109 Gloucester Avenue
London, NW1 8LB

Basement Impact Assessment
Audit

For
London Borough of Camden

Project Number: 12336-77

DAMAGE CATEGORY ASSESSMENT.

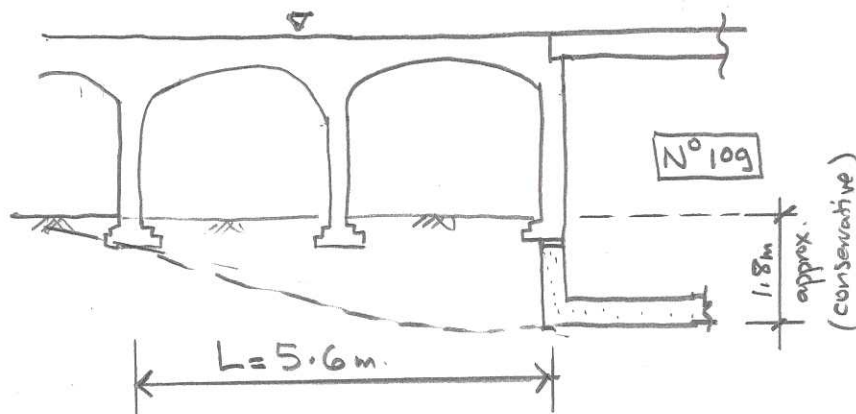
It is stated in the conclusions that the anticipated damage is likely to be 'Category 1 (Negligible)'. Category 1 is 'very slight' damage whilst Negligible damage is Category 0. Please clarify. If Category 1 damage is anticipated, please refer to CPG4 (2015) paragraph 3.30 on the need for mitigation measures.

- Query no. 7 – Please see attached calculation and sketch for the ground movement assessment as requested. We have added a plan to show anticipated movement contours and clarified the sketch section on pg M1A. Mitigation measures have been described in the original BIA text and an outline sequence of construction sketch included for clarity – see pg 33. The works are to be carried out in short hit and miss excavations with high and low level temporary propping to the existing walls during the works.

Project Number: 1699	Project: 109 Gloucester Avenue, London	Scale: NTS
Figure 3	Trial Pits and Borehole Location Plan

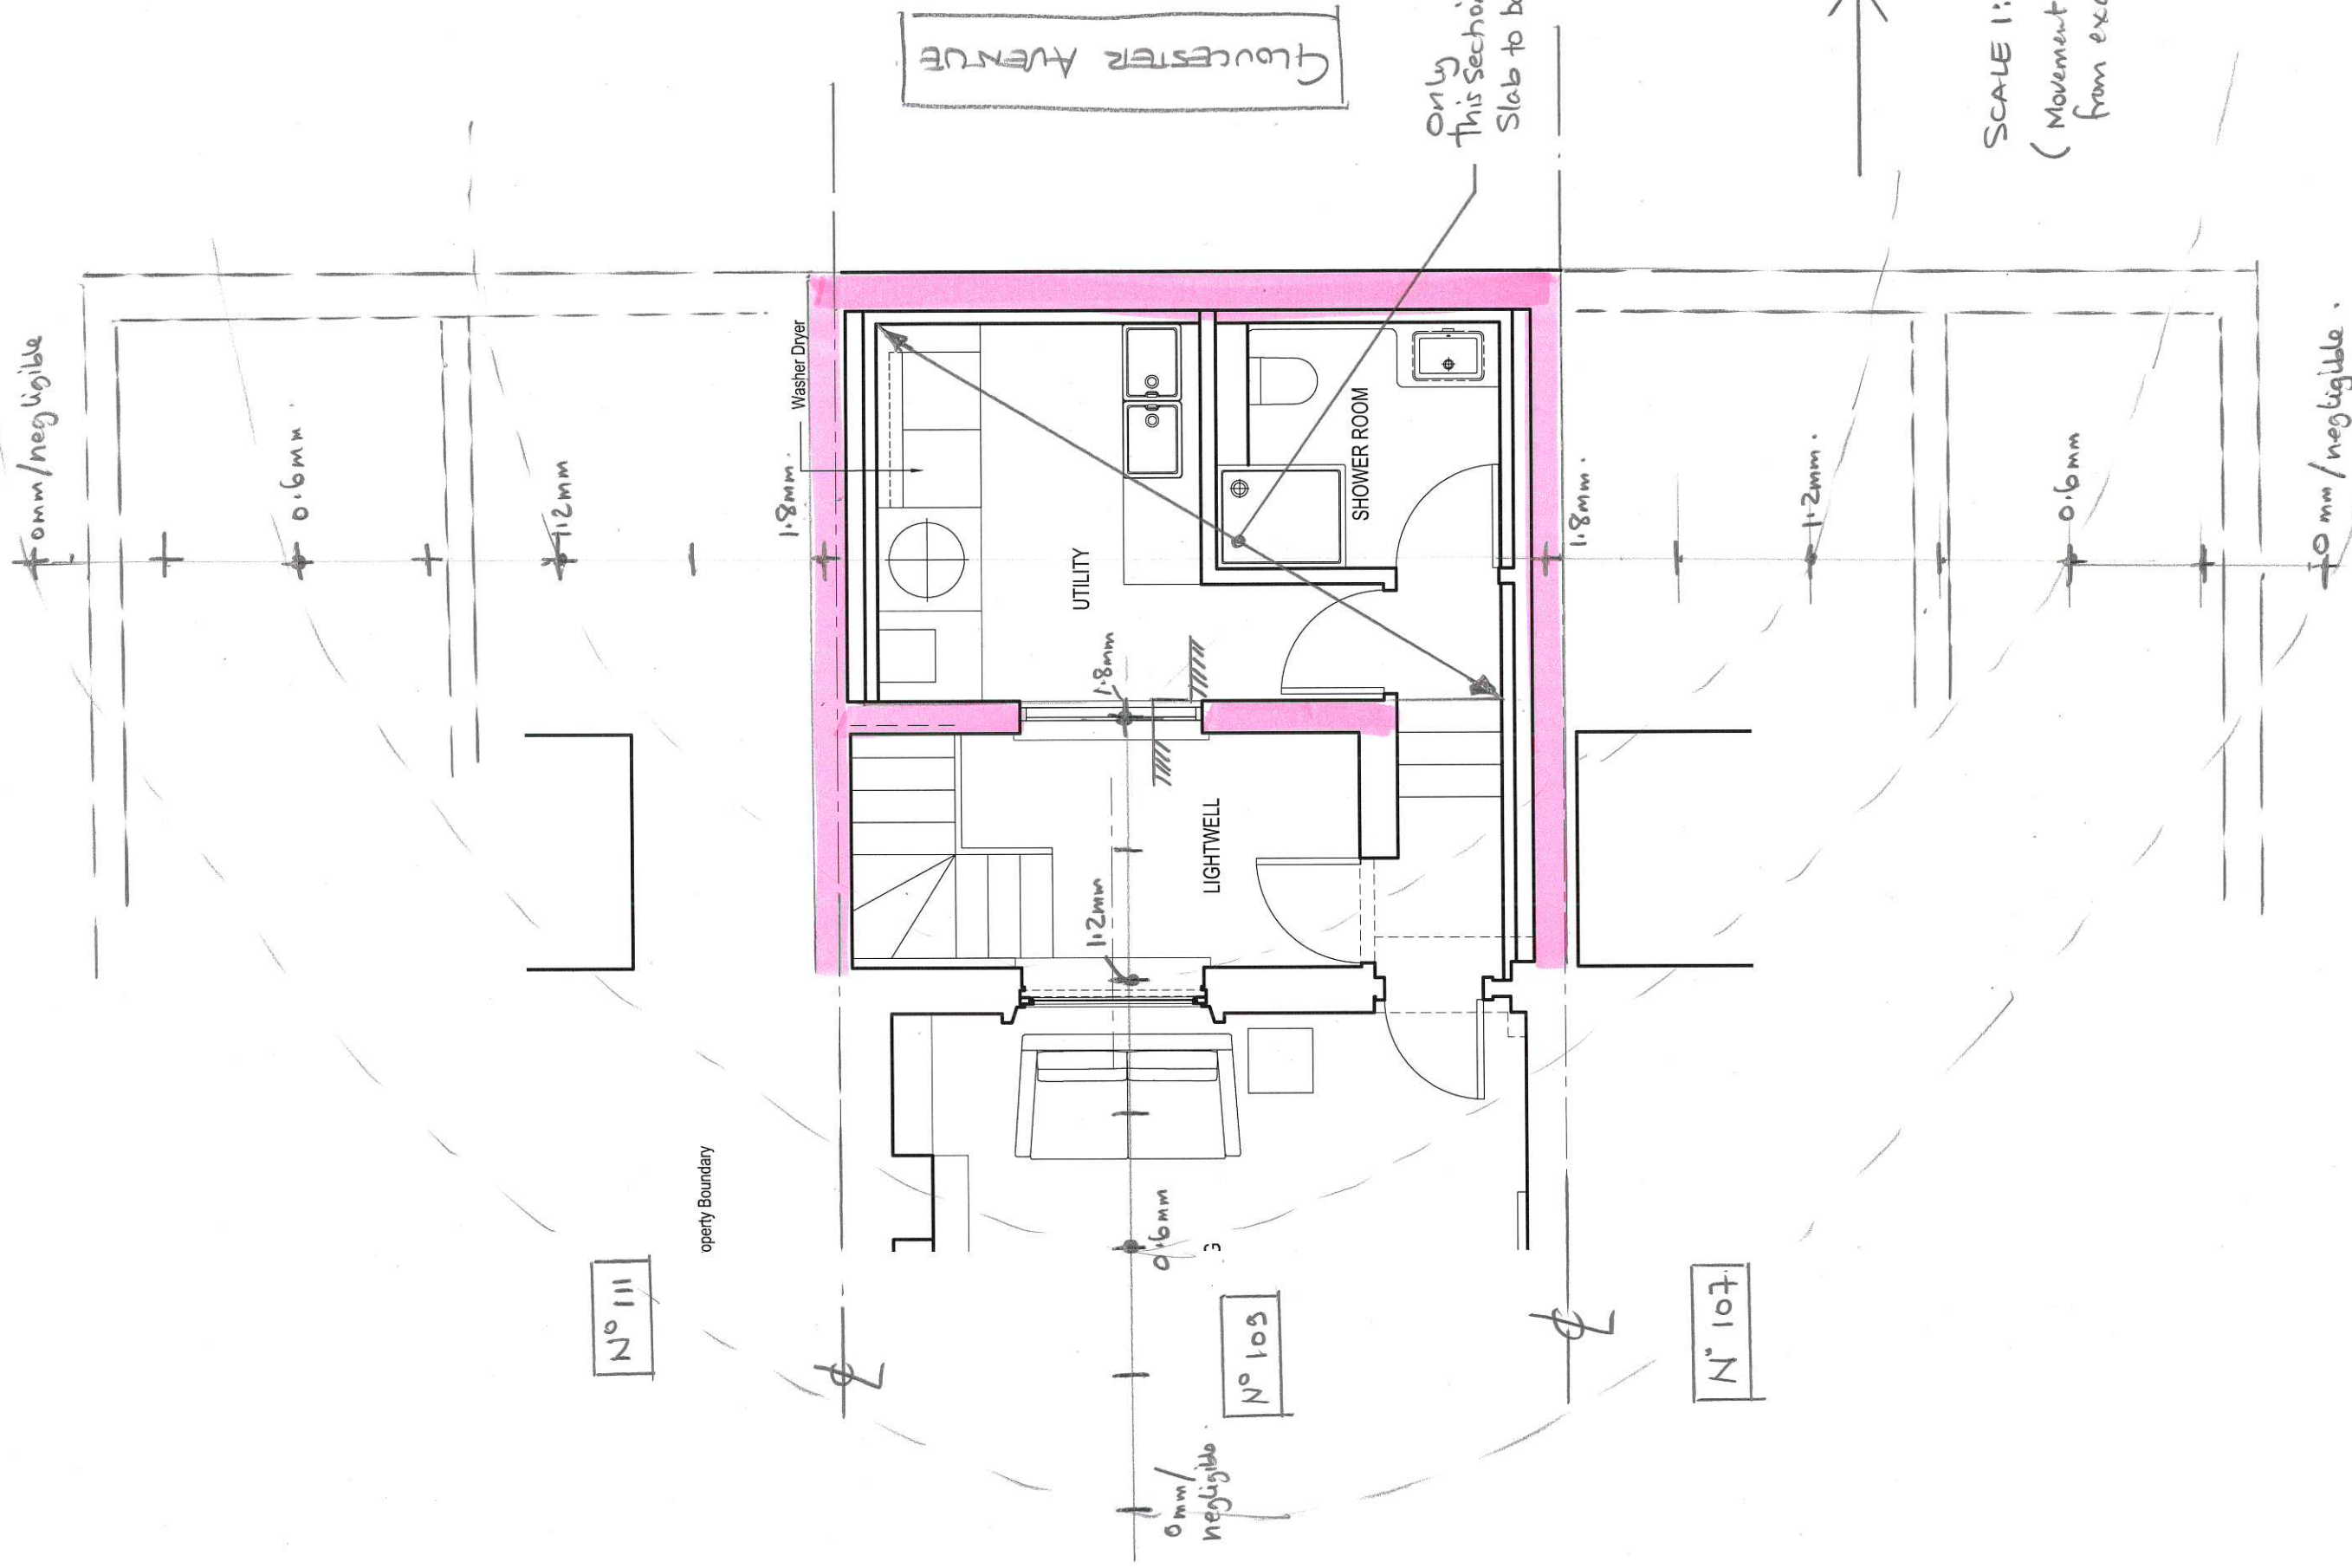
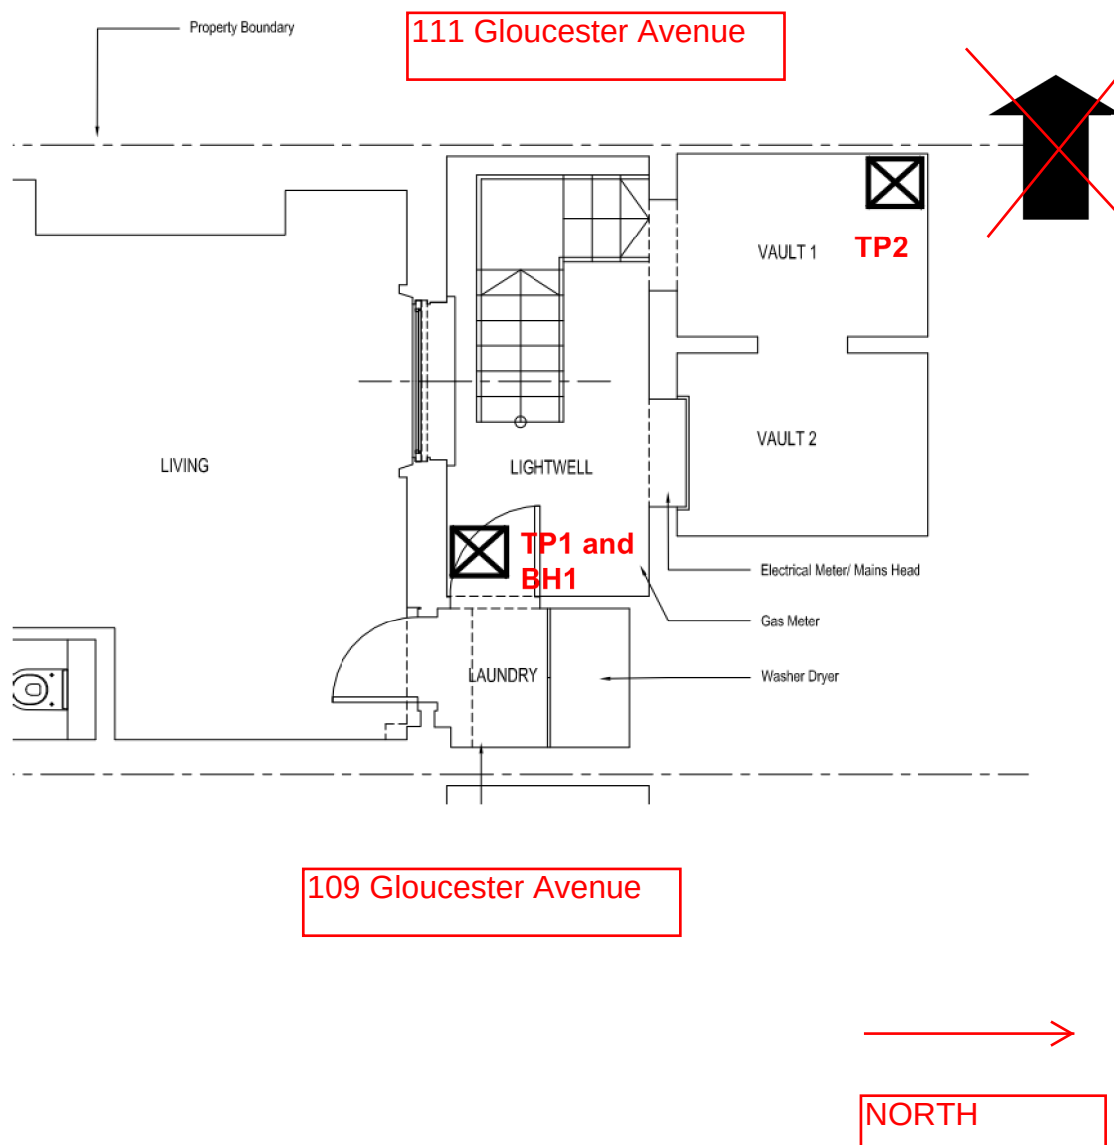
The ground investigation encountered Made Ground to a maximum depth of 1.30m below the vaults. It is stated in the BIA that the required excavation depth is approx. 1.20m. Please clarify the depth of underpinning to confirm these will be founded in competent strata. It is stated in non technical summary of the slope stability screening that 'groundwater was not encountered in the investigation, therefore

- Query no. 9 - The trial hole location plan with amendments is attached. North arrow and property numbers are marked up. The trial hole was adjacent to 111 Gloucester Avenue.
